ARCHITECTURAL REVIEW BOARD STAFF REPORT

Project #/Name	ARB-2022-97: The Trading Post BP Canopy Reface and Freestanding Sign
Review Type	Certificate of Appropriateness for Canopy Reface and Freestanding Sign
Parcel Identification	087B0-00-00-00400
Location	3017 Monacan Trail Road at the southwest corner of the intersection with Taylors Gap Road (Fig. 1)
Zoned	Rural Areas (RA) / Entrance Corridor (EC)
Owner/Applicant	North Garden LLC/TVS Food Mart Inc. (Sunil Kapoor) / Interstate Sign Company (Brittney Garren/David Slate)
Magisterial District	Samuel Miller
Proposal	To reface the existing fuel pump canopy with a 3-D fascia band, to add 3 canopy signs (‘Helios’ graphics/logos) (Fig. 2), and to install a pylon sign (Fig. 3).
Context	The character of this portion of the Entrance Corridor is largely rural and residential.
Visibility	The north, east, and west sides of the canopy are visible from the EC (Rt. 29).
ARB Meeting Date	January 3, 2023
Staff Contact	Khrist Taggart

Figure 2: Drawings from ARB2022-97: Trading Post BP Canopy Reface and Monument Sign Application.

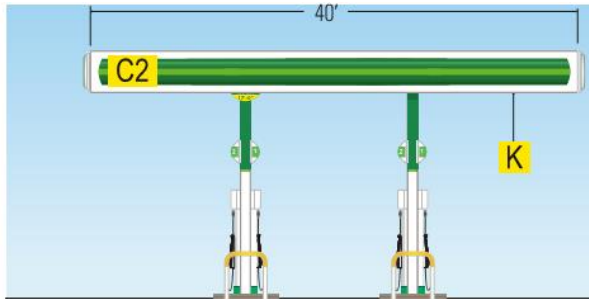
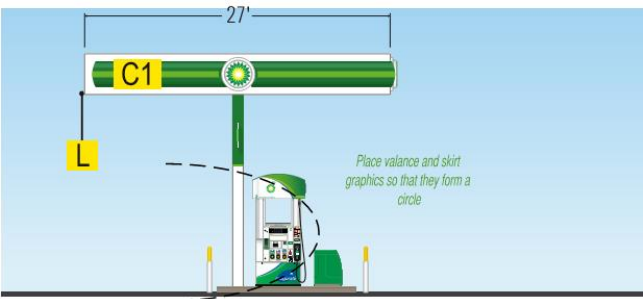
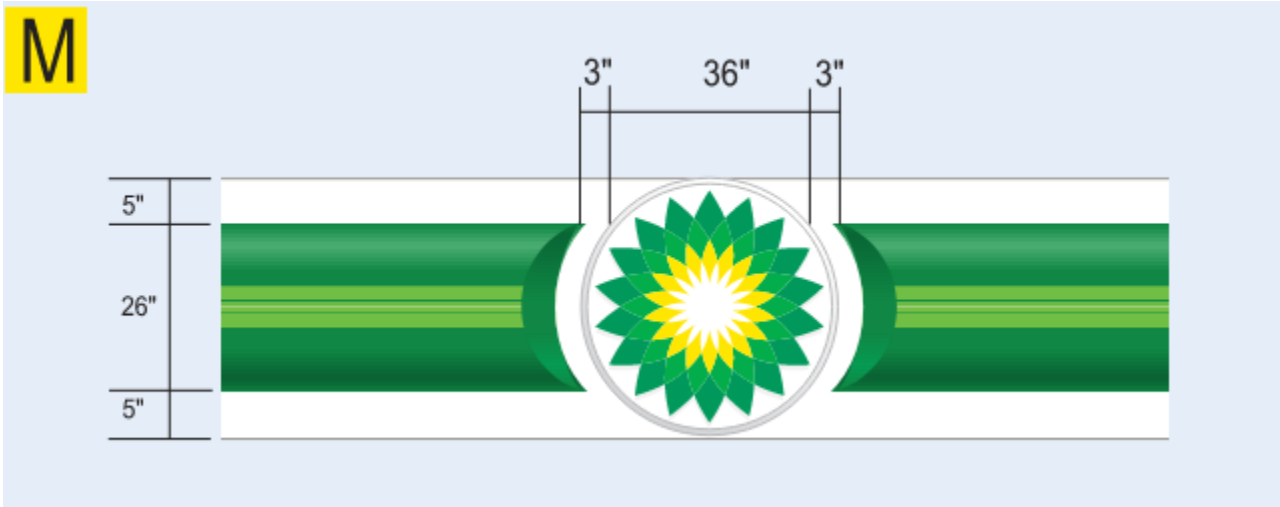
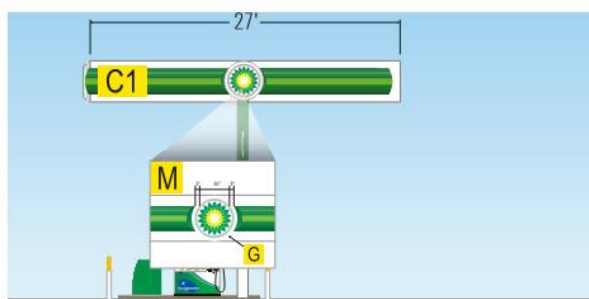
REF	GUIDELINES	ISSUE	RECOMMENDATION
	Fuel Pump Canopies		
45a	Fuel pump canopies may be required to provide customers with protection from the elements and to provide lighting levels required for dispensing fuel. Such fuel pump canopies are functional elements of present-day gas/convenience stores and their character and appearance shall reflect a minimalist design consistent with that function.	The changes to the fascia include a 2-color, 3-dimensional band and a 4-color ‘Helios’ graphic on the north (front), east (left), and west (right) sides of the canopy (Fig. 2, Fig. 4), and a flat ACM band on the south (back) side of the canopy (Fig. 2). The background of the canopy, white, is expected to have an appropriate appearance. However, the multicolor 3-D band does not meet the “one principal color” guideline and the dimensional design of the band and color variety do not establish a minimalist design. The shift to white, green and yellow colors will emphasize the canopy and its components on site, and differentiate the canopy from the store building. In other reviews of BP fuel pump canopies in the County, the multicolored band has not been considered appropriate and the canopy face color has been limited to a single color or a principal color and an accent color with ‘Helios’ graphics/logos.  BP fuel pump canopy, 6115 Rockfish Gap Turnpike.  BP fuel pump canopy, 241 Rolkin Road.	Revise the proposal to limit the band on the fascia to a single color and remove the dimensional band design.

45f	Canopy related elements, including fuel dispensers, support columns, spandrels, planters, etc. shall be compatible with the character of the building and site and shall not be used for advertising.	The sign drawings show changes to the fuel dispensers and canopy support columns that include branding colors and graphics. These designs do not complement the character of the building and function as advertising. Revising the support columns to be more compatible with the character of the existing building could reduce the overall impact of the trademark colors.	Revise the support columns to a color that is more compatible with the existing building.
	General Sign Guidelines		
1	Create a consistent and unified design approach along the Entrance Corridors. The <i>placement, size, illumination</i> and <i>colors</i> of signs can create unity along the corridor, or they can create a disjointed, visually competitive environment. Consistent and unified sign design allows the businesses located along the Corridor to have equal standing in visibility. It also provides a pattern of sign placement that makes the business locations and entrances more easily recognizable to both vehicular and pedestrian traffic.	The character of this portion of the Entrance Corridor is largely rural and residential with intermittent commercial parcels. The designs of the proposed canopy refacing and monument sign are ones that establish brand identity, but they are not reserved and do not relate to the existing building or the rural surroundings. Revisions to the canopy refacing and freestanding sign that simplify the designs could help better integrate them with the existing building and the surrounding context.	See recommendations below.

For raceway-mounted channel letters, raceways shall match the wall color.		
11b	The use of three colors or less is more appropriate for canopy signs in the Entrance Corridors. Black and white are counted as colors.		
4f	Trademarks, corporate logos and graphics: The ARB may require that the color and scale of standard templates for trademarks, service marks, corporate logos and graphics be modified. When used, trademarks, service marks, corporate logos and/or graphics should be incorporated as an integral part of the overall sign.		
9d	The size of a wall sign shall be coordinated with the size of the architectural element on which it is placed. The sign should not overcrowd the architectural element, the wall, or the sign area. Buildings and building elements should not be used as a billboard. For example, an appropriate height for channel letters in a 30" high sign band is 18". This allows 6" of unoccupied space above and below the letters. Generally, 4" of clear space above, below, and to the sides of a channel letter sign is considered a minimum, with larger clearances required for larger sign bands. The ARB will consider the degree of visibility, the distance from the Entrance Corridor, and the architectural design of the building and the sign area in its determination of appropriate sizes and placement.	A complete sign package has been submitted for review. The proposed ‘Helios’ graphics are the same height (36”) as the fascia. This height will not allow for any clear space above and below the graphics. Revising the graphics to the 30” ‘Helios’ option shown in the checklist on page 1 of the sign drawings would allow for appropriate clear space above and below the graphics.	Revise the height of the ‘Helios’ signs for the canopy to not exceed 30”.

1. Revise the proposal to limit the band on the fascia to a single color and remove the dimensional band design.
2. Revise the support columns to a color that is more compatible with the existing building.
3. Revise the height of the ‘Helios’ signs for the canopy to not exceed 30”.
4. Revise the drawings to include a detail of the ‘Helios’ canopy sign and notes to clarify that the sides, rear, and background of the signs will be opaque.

Figure 3: Drawings from ARB2022-97: Trading Post BP Canopy Reface and Freestanding Sign Application.

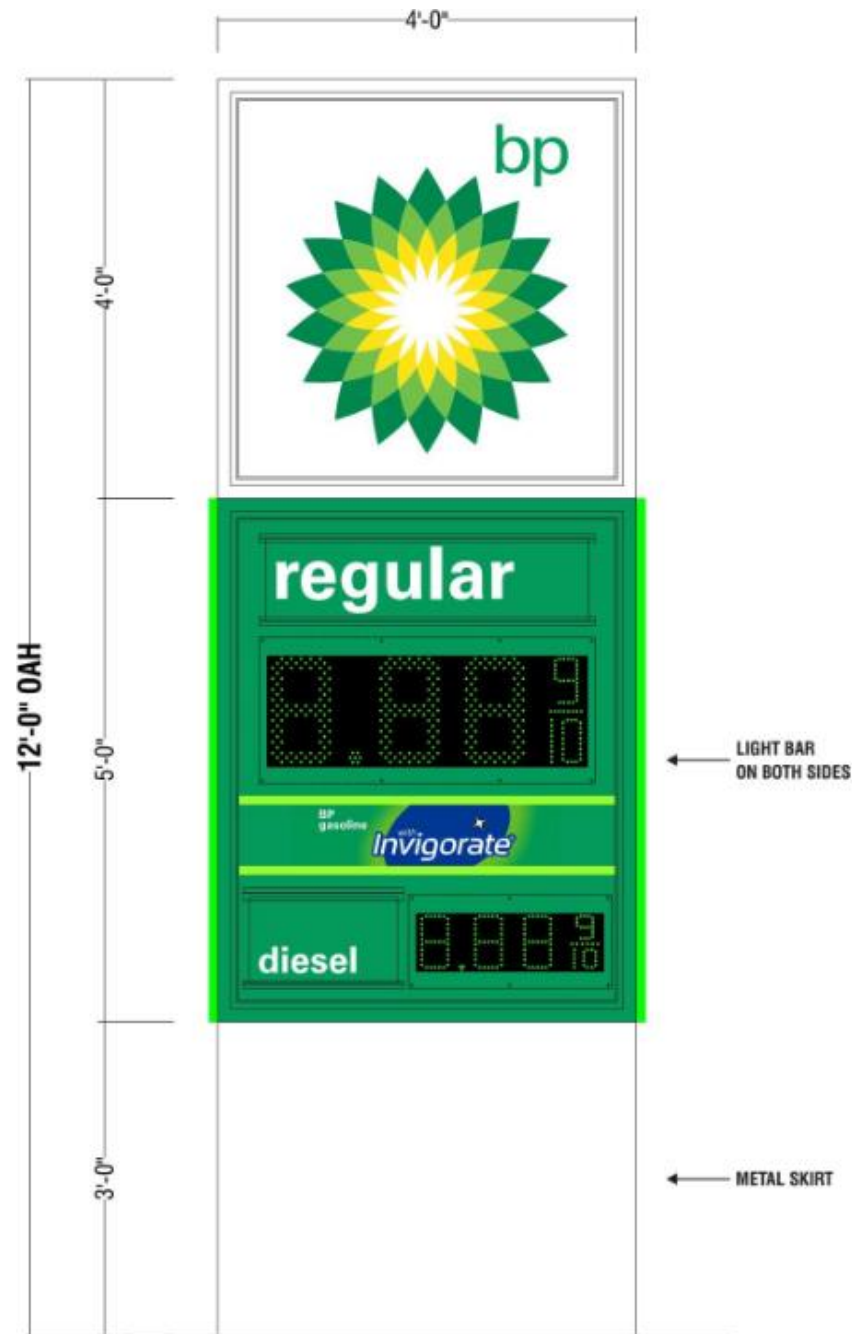
5f	Internal Illumination: Any internal illumination is considered to contribute to visual clutter and will be limited.		
5g	All illumination shall be non-blinking.	There is no blinking illumination proposed.	None.
5h	Exposed Light Sources: An exposed light source that forms the body of a sign, such as but not limited to signs formed of exposed neon, as opposed to a light shining on a sign, shall not be used in the Entrance Corridors.	The drawing for the pylon sign shows a light bar on either side of the sign. The night-time view does not show these bars as illuminated but eliminating them from the design would ensure consistency with EC Sign Guidelines.	Eliminate the light bar on the sides of the pylon sign.
8e, 9e	<i>i.</i> External illumination is preferred for wall and freestanding signs.

ii. Freestanding Sign External Illumination: Landscaping for monument and pole signs should be designed to shield ground-mounted lighting so that it is not visible from any adjacent property or right-of-way. Wall Sign External Illumination: Lighting directed toward a sign should be designed and shielded so that it illuminates the face of the sign and does not shine beyond the edge of the sign.	Wall Sign: Internal illumination (face-lit) is proposed. The ‘Helios’ graphics on the canopy appear to be constructed like a cabinet sign, but the drawings do not note which portions of the sign are opaque. A detail of the ‘Helios’ graphic would clarify the areas of illumination. Freestanding Sign: Internal illumination (face-lit) is proposed. Most of the background of the sign and fuel price areas on the freestanding sign have been indicated as opaque. However, the note is not included with the daytime view of the sign, and the nighttime view shows that the blue and green area behind ‘with Invigorate’ is illuminated. Revising this background to be opaque would be consistent with EC Guidelines.	Revise the drawings to include a detail of the ‘Helios’ canopy sign and notes to clarify that the sides, rear, and background of the signs will be opaque. Revise the daytime pylon view to note that only the white text and green LED prices shall be illuminated on the fuel price cabinet. Revise the daytime pylon view to note that only the BP in the upper right corner and the ‘Helios’ logo in the middle of the sign shall be illuminated on the sign cabinet.

8	FREESTANDING SIGNS		
8a	Monument signs are preferred to pole-mounted signs because they are often of a smaller scale and can be more fully integrated into the overall development. Pole signs may be considered for approval if existing site conditions rule out the ability to use a monument sign, and only when the pole is in proportion to the sign cabinet or panel.	A pylon-style sign is proposed near the northeast corner of the site in the right-of-way. The right-of-way will need to be acquired prior to the approval of the sign permit. This section of Rt. 29 is primarily rural in character with little commercial signage. The pylon form of the proposed sign, the height, and the colored metal material are expected to result in a sign that looks out of place in the surroundings. A monument-style sign (with a lower, horizontal profile) and a darker base (brick to match the building or a dark green to blend with landscaping) could help establish a more coordinated appearance.	Consider revising the freestanding sign to a monument-style sign with a lower, horizontal profile. Revise the base of the pylon sign to brick to coordinate with the building.

8b	Materials used in both the sign and support structures should be complementary. They should also support the aesthetics of the building and /or complex being served by the sign, although a direct duplication is not necessary. It is preferred that the base material match one of the primary building materials unless the design of the sign represents itself as a freestanding element complementing the building.		
8c	The structure of a monument sign shall not overwhelm the sign. The structure and the sign that it supports must be in proportion to each other.		
8d	Landscaping: Use ground cover, shrubs and/or trees to integrate freestanding signs into the overall landscape development of the site. Refer to the Albemarle County Recommended Plants List, which is included in the Albemarle County Architectural Review Board Design Guidelines and is available on-line at www.albemarle.org .	No landscaping is proposed. A variety of plant types – ground cover, shrubs, etc., - could help integrate the sign into the overall site and help establish a more orderly and attractive appearance for the planting island where the sign is being located.	Revise the sign drawing to show landscaping to integrate the sign into the surrounding context.

1. Eliminate the light bar on the sides of the pylon sign.
2. Revise the daytime pylon view to note that only the white text and green LED prices shall be illuminated on the fuel price cabinet.
3. Revise the daytime pylon view to note that only the BP in the upper right corner and the ‘Helios’ logo in the middle of the sign shall be illuminated on the sign cabinet.
4. Consider revising the freestanding sign to a monument-style sign with a lower, horizontal profile
5. Revise the base of the pylon sign to brick to coordinate with the building.
6. Revise the sign drawing to show landscaping to integrate the sign into the surrounding context.
